Office Action Summary

10/673,510

OKAZAWA ET AL.

DETAILED ACTION

Drawing A: Figure 2 of Miura et al., edited for clarification

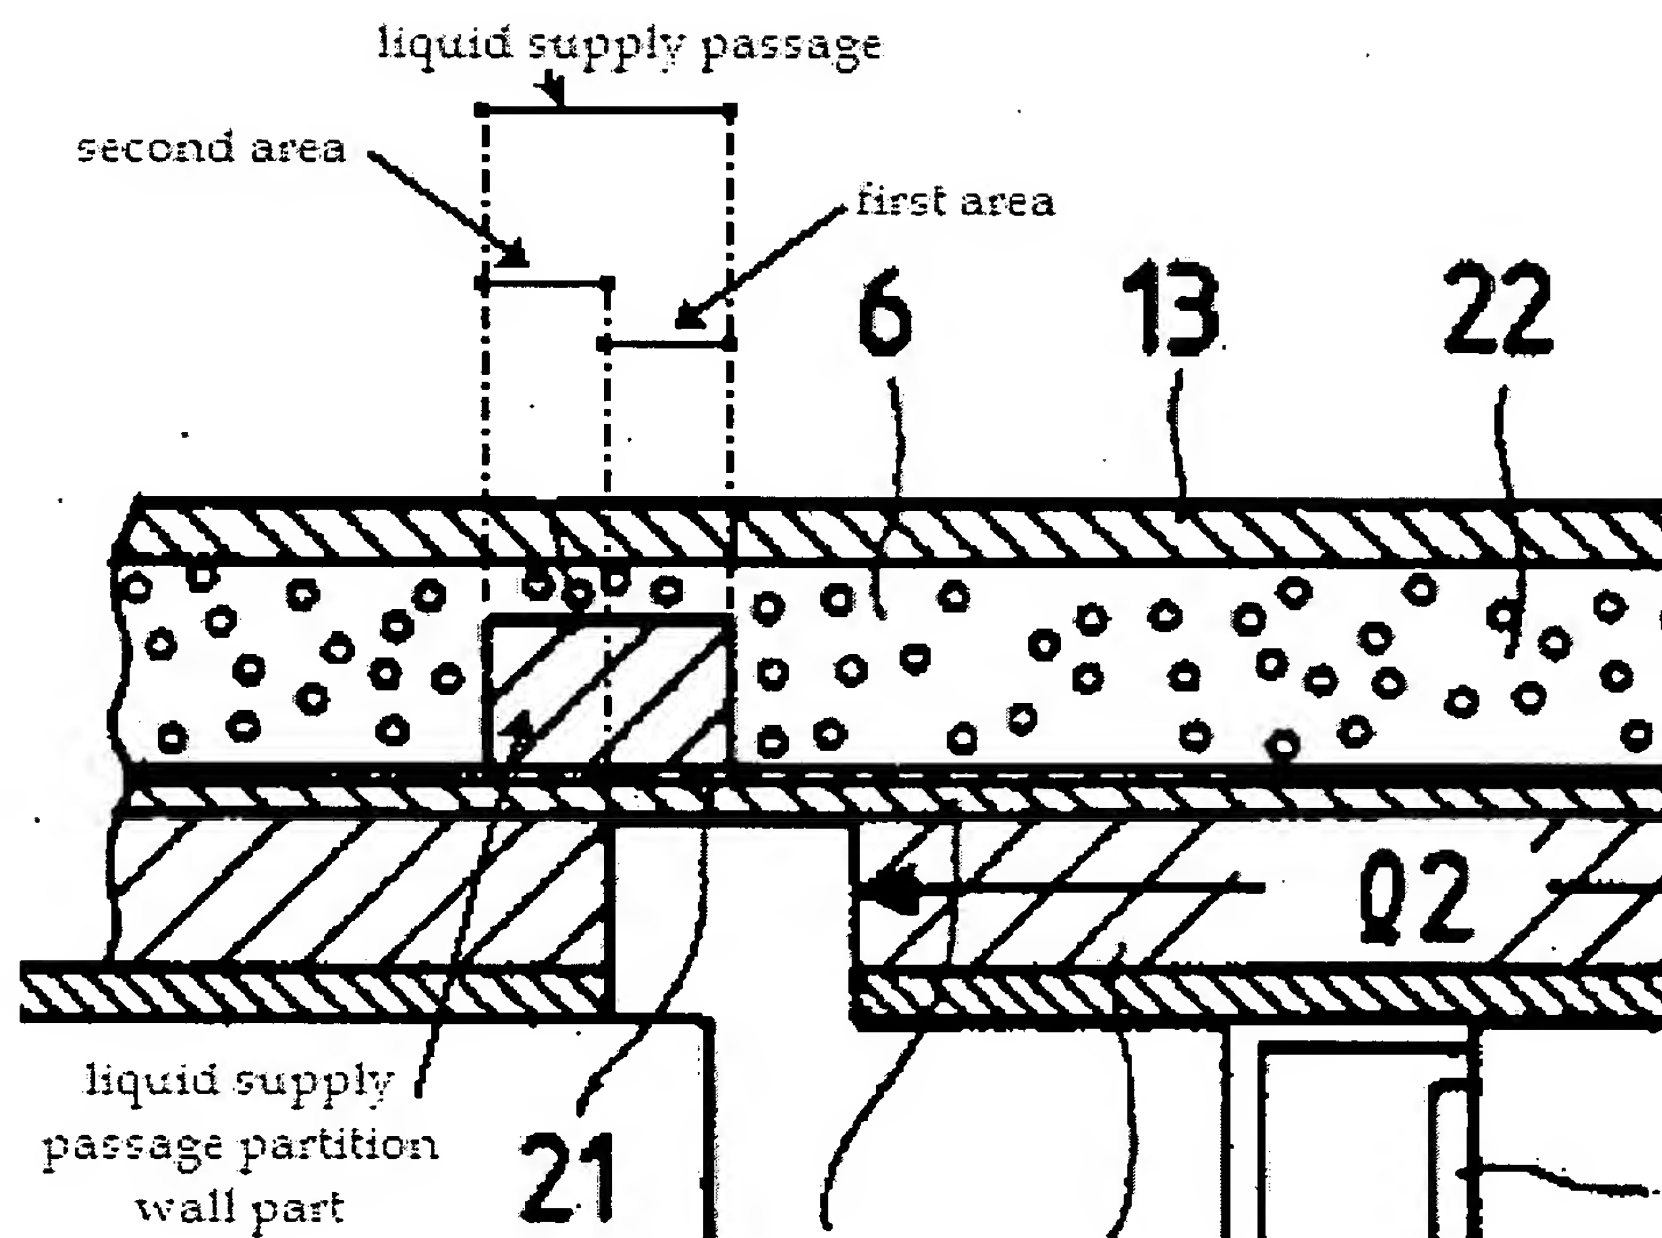
a plurality of liquid supply passages (liquid supply passages; see Drawing A below) that supply liquid to the pressure generation parts, respectively (Fig. 2);

wherein the partition wall parts respectively include liquid supply passage partition wall parts (liquid supply passage partition wall parts; Drawing A) that separate adjacent liquid supply passages (Figs. 1 and 2);

wherein the sealing section seals an area of the flow passage formation section corresponding to both the liquid supply passage partition wall parts and the liquid supply passage of the flow passage formation section (Fig. 1), and the sealing section has a first area (first area; Drawing A) and a second area (second area; Drawing A) that is greater in thickness than the first area (Drawing A);

wherein both the first area and the second area are opposed to the liquid supply passage (Drawing A); and

wherein the head case section is separated by a vacancy from the section at the first area opposed to the liquid supply passage (Drawing A and Fig. 2).

Miura et al. also disclose that the metal thin film is formed on the sealing section of the portions corresponding to the partition wall parts as the second part (Drawing A).

Miura et al. disclose all the limitations of claim 20, as well as the limitations that the second part inside of the area where the head case section is provided on the sealing section is placed in a part of each of the liquid supply passage partition wall parts (Drawing A).

Miura et al. also disclose that the second part is placed at a tip side away from the pressure generation parts in the liquid supply passage partition wall parts (Drawing A).

Miura et al. also disclose that the second part is placed only in the tip side of the liquid supply passage partition wall parts (Drawing A).

Miura et al. disclose all the limitations of claim 24, as well as the limitation that the second part of the sealing section (20b+24) is placed in the liquid supply passage partition wall part (Drawing A), to which the head case section is joined (Fig. 2), has an area smaller than an area of the corresponding liquid supply passage partition wall parts (Drawing A).

Miura et al. disclose all the limitations of claim 25, as well as the limitation that the second part (20b+24) inside of the area where the head case section (10) is provided on the sealing section is placed in a part of the liquid supply passage partition wall parts (Drawing A).
